MODIFICATION TO CONNECT TO TOYOTA 8 WAY CONNECTOR

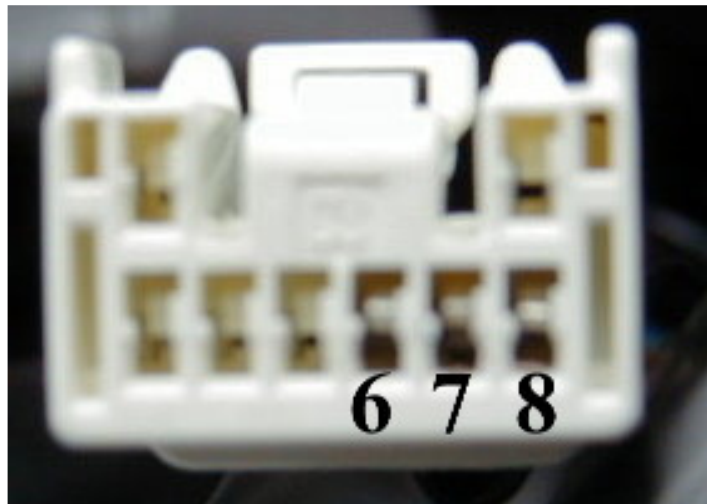
REMOVE WHITE 20 WAY CONNECTOR LEAVING BLACK, BLUE & VIOLET WIRES.

**CONNECT BLACK WIRE TO PIN 6.
CONNECT BLUE WIRE TO PIN 7.
CONNECT VIOLET WIRE TO PIN 8.**
